To: Larson Construction	Project: East Hall Renovation
Date: 08.04.2025	Project #: 25030
Owner: Kirkwood Community College	Transmit Via: Email

The information contained in this Addendum modifies, supplements, or replaces information contained in the original Permit Set dated July 23rd, 2026, as noted below. This information is hereby made a part of the Construction Documents.

1
AD111.A

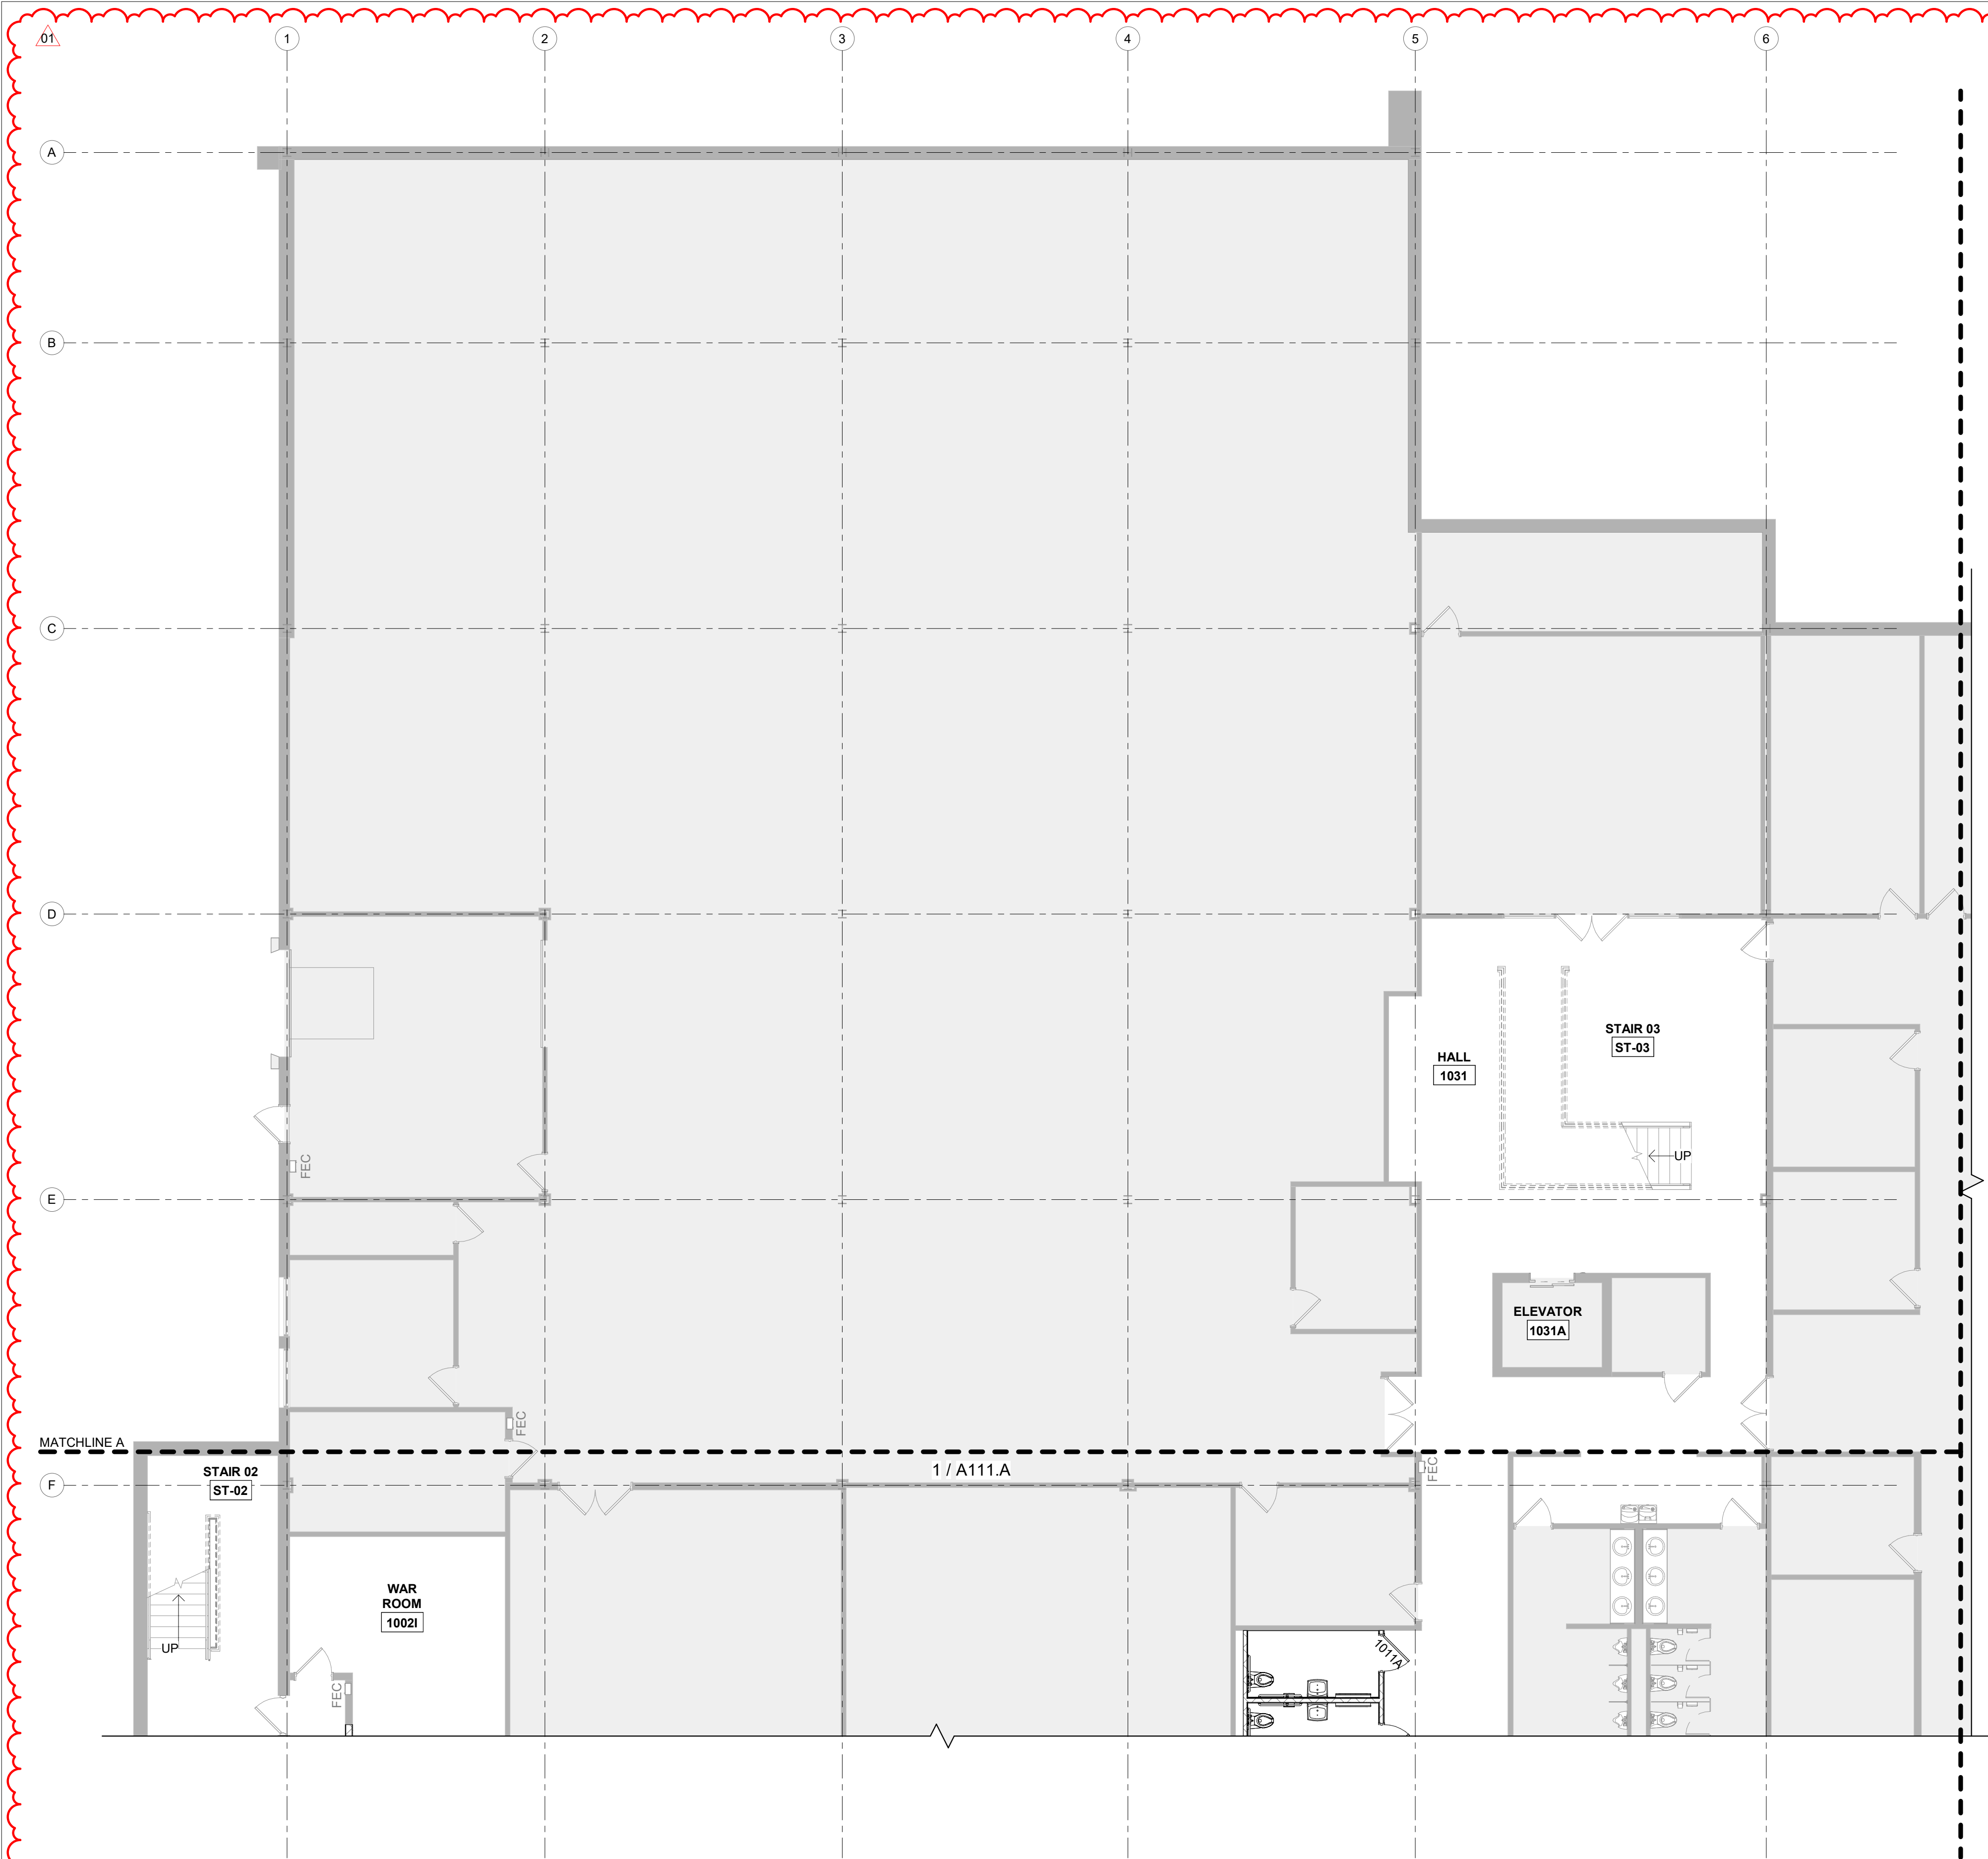
- 1. SHEET AD111.A – Demolition Floor Plan – Level 1 – Area A**
SHEET AD111.B – Demolition Floor Plan – Level 1 – Area B
SHEET AD112.A – Demolition Floor Plan – Level 2 – Area A
SHEET AD112.B – Demolition Floor Plan – Level 2 – Area B

- a. REVISE Keynote 4 as follows: "EXISTING FLOOR FINISHES & WALL BASE - DEMOLISH & REMOVE. PREPARE FOR NEW. SALVAGE FULL CARPET TILES FOR OWNER'S USE."
- b. ADD Keynote 15 as follows: "EXISTING CONCRETE FLOOR - SAWCUT CLEAN & DEMOLISH FOR ELECTRICAL WORK. SEE ELECTRICAL." See attached AD111.A for keynote location and scope of work.

3. SHEET A602 – Door & Window Schedule

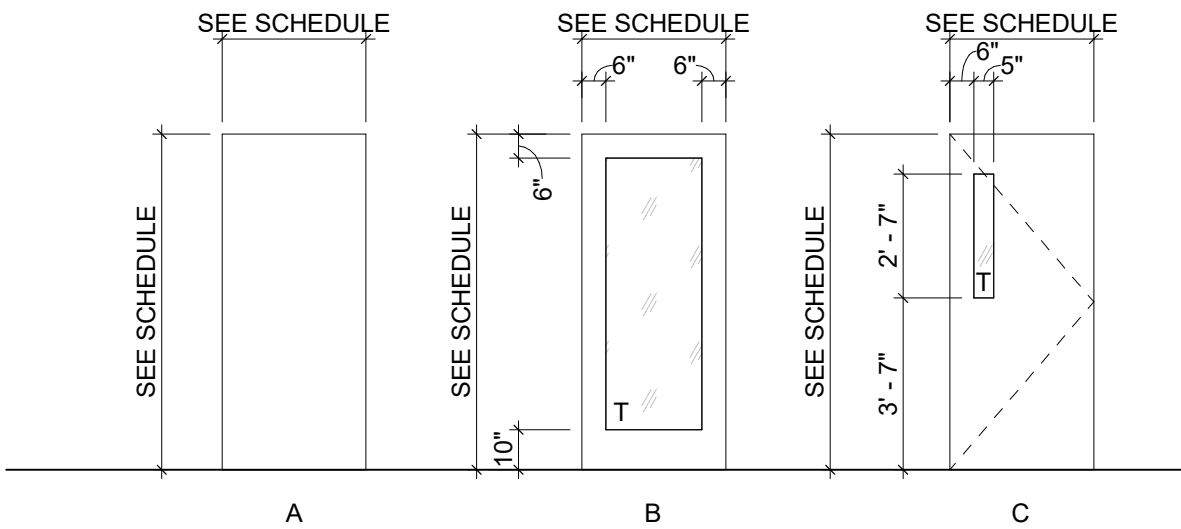
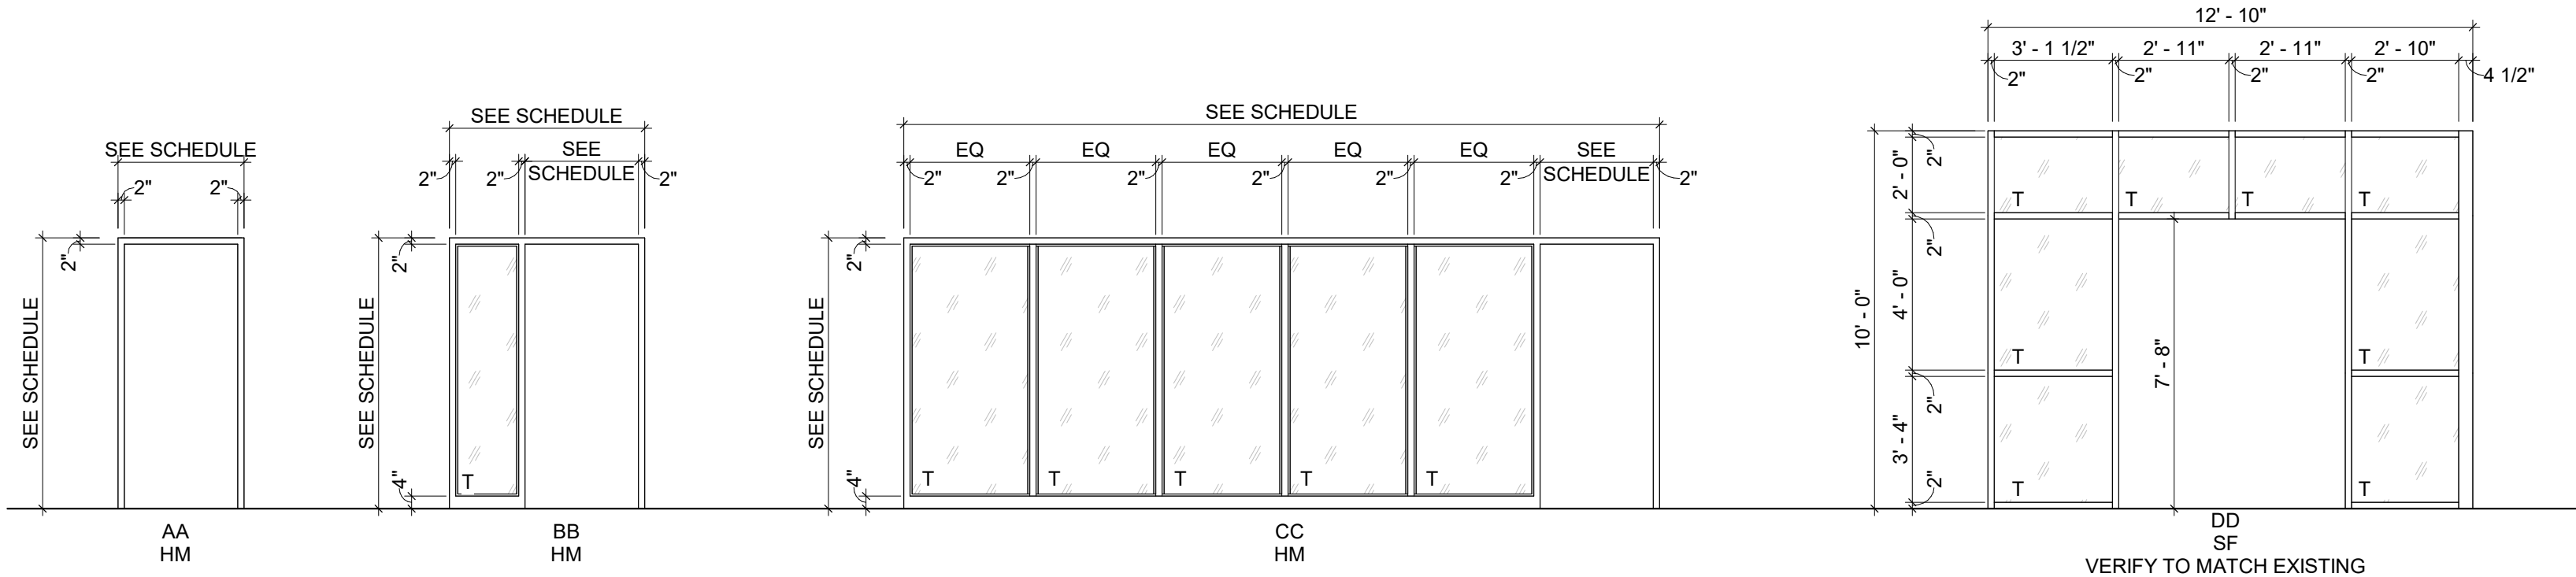
- a. ADD new card reader to existing door ST-02A. See attached A602.

Power Plan - Level 1 - Area A

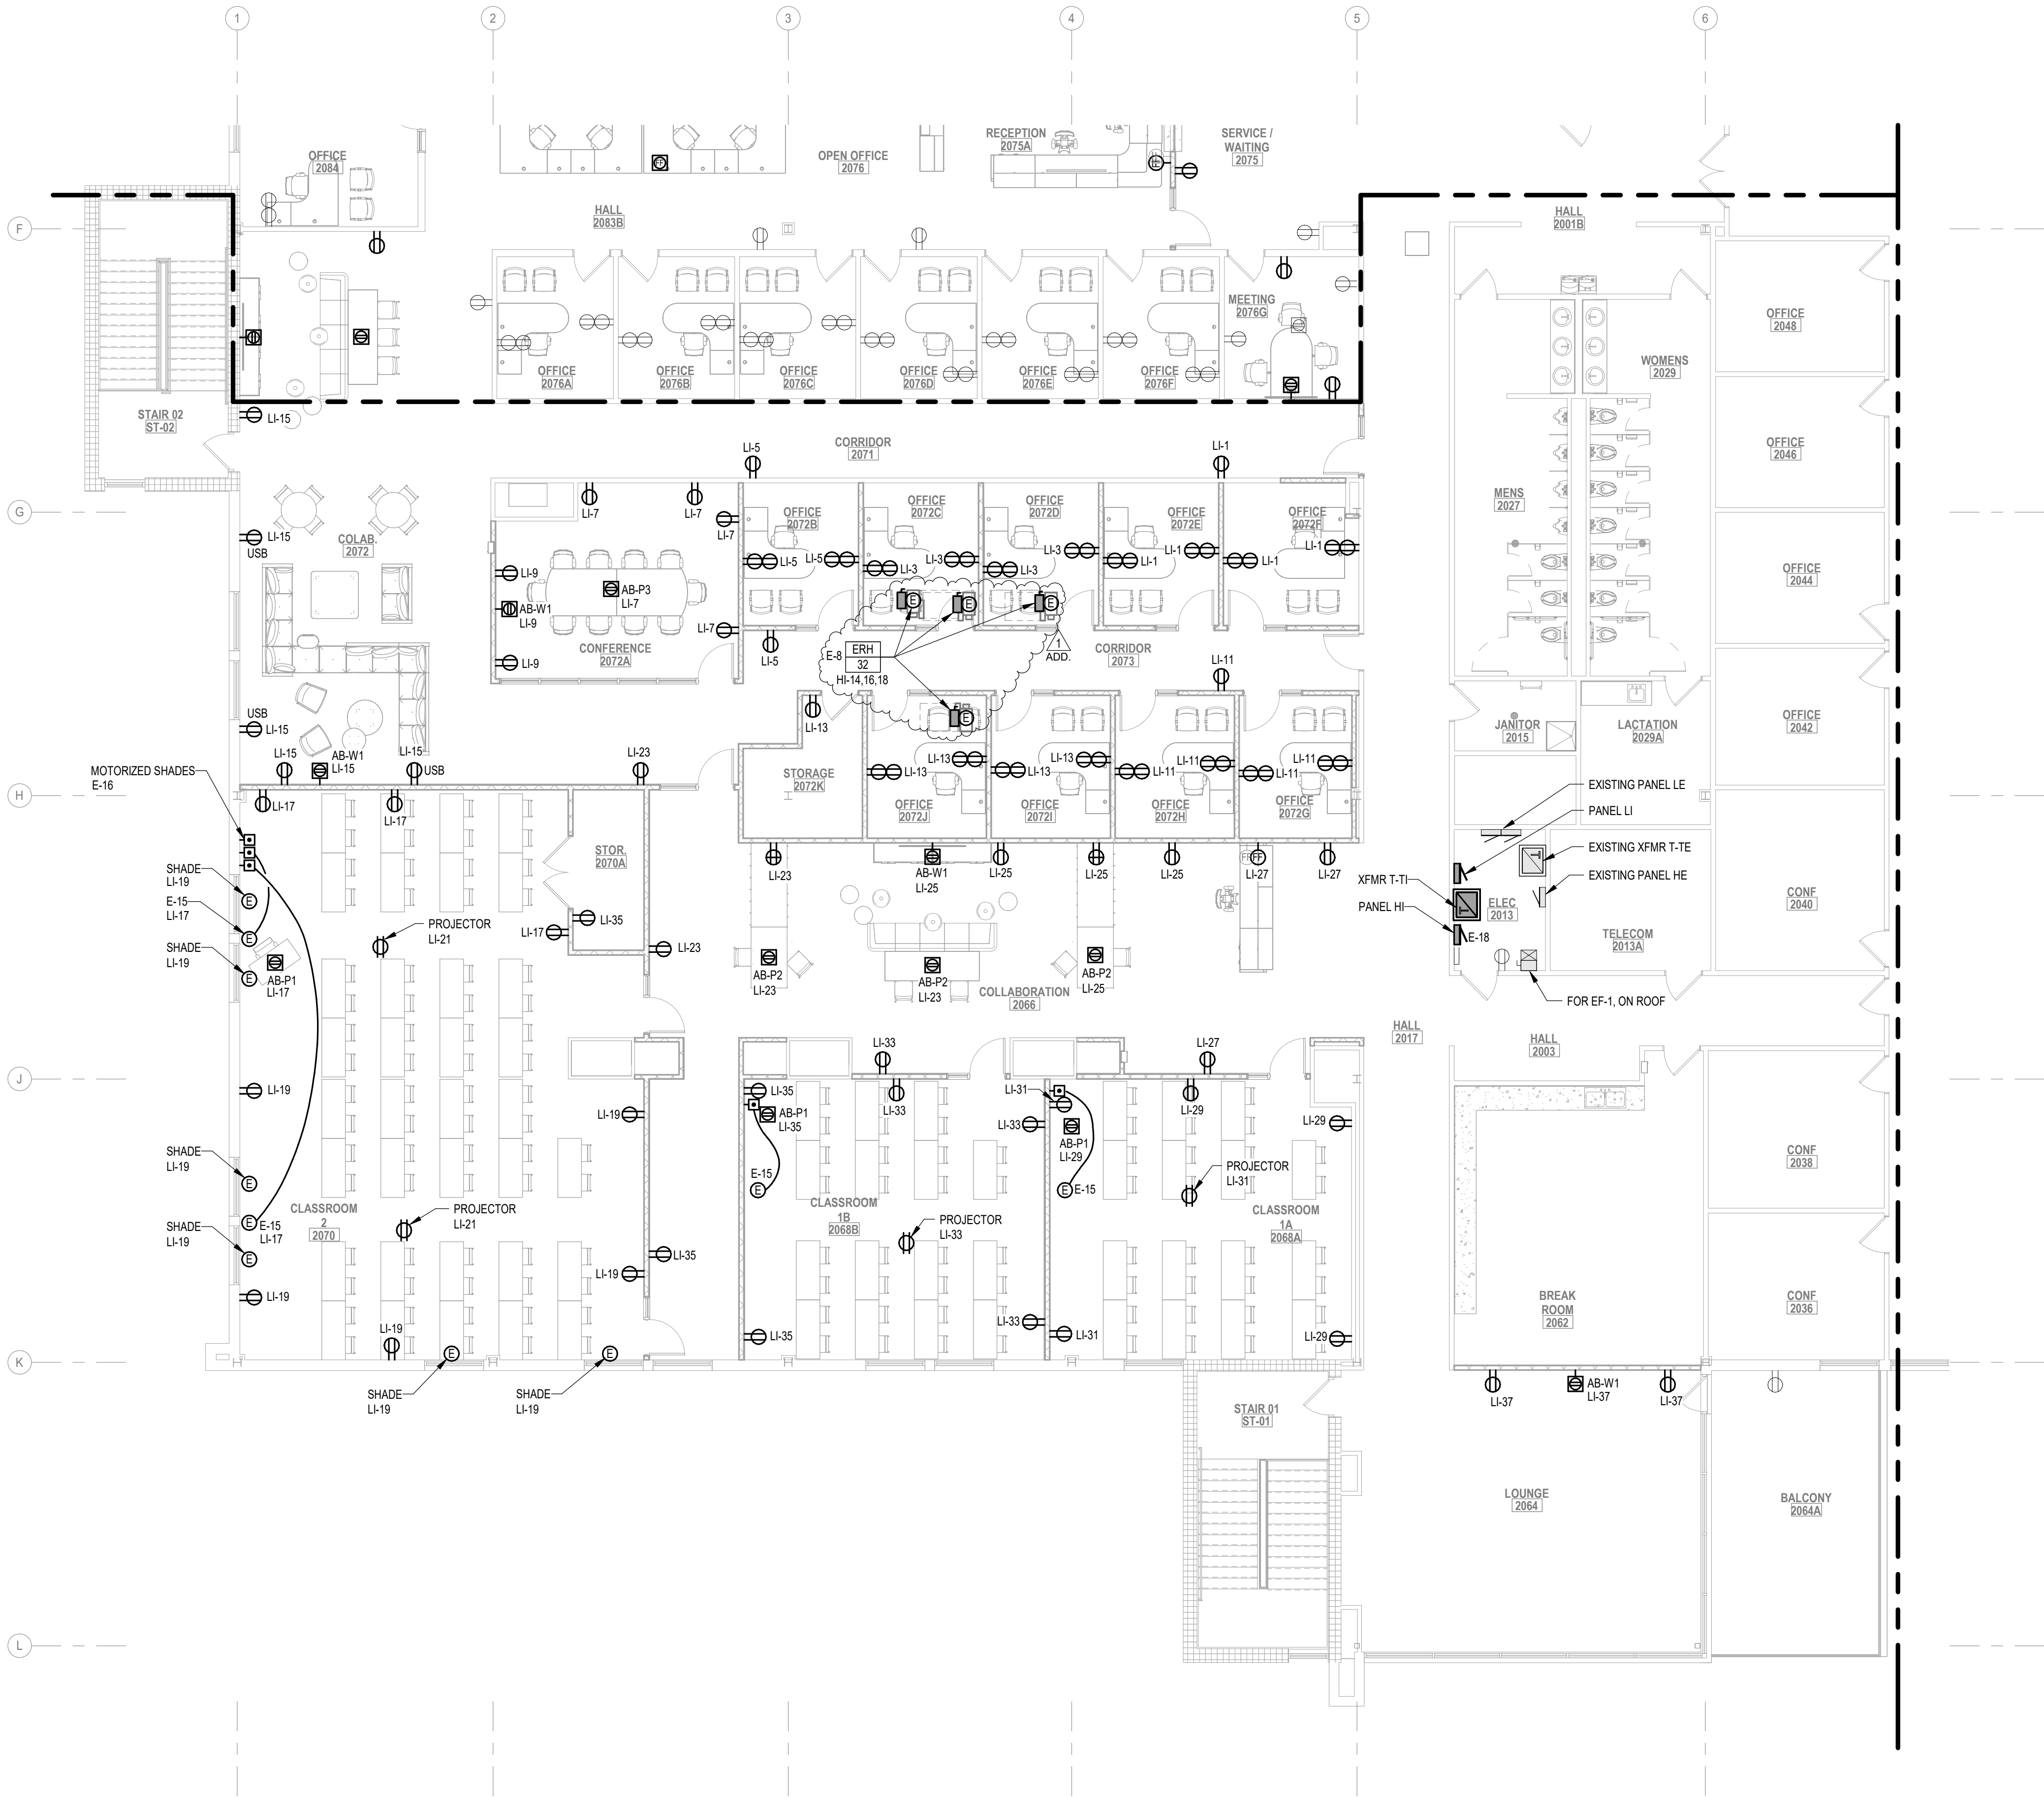
6. SHEET E211.A - Power Plan - Level 1 - Area A

- a. DELETE: All new ERCP-1s
- b. ADD: Electric Reheat connections (ERH-28) to VAVs served from RTU-28.
- c. REVISE: Keynote E-8.

KEYED NOTES	
E-8	480V, 3-PHASE ELECTRIC REHEAT PROVIDED WITH FUSED DISCONNECT SWITCH. CONNECT TO 480V, 30A SHARED CIRCUIT NOTED.
E-15	120V CONNECTION TO MOTORIZED PROJECTION SCREEN. PROJECTION SCREEN PROVIDED BY OWNER. INSTALL CONTROL SWITCH.
E-16	MOTORIZED SHADE CONTROL. COORDINATE REQUIREMENTS WITH SHADE SUPPLIER AND GC.
E-18	RELOCATE TIMER SWITCH TO ALLOW ROOM FOR NEW ELECTRICAL EQUIPMENT. PROVIDE CHANNEL STRUT AS REQUIRED TO ALLOW EXISTING RACEWAY TO PASS BEHIND EQUIPMENT.
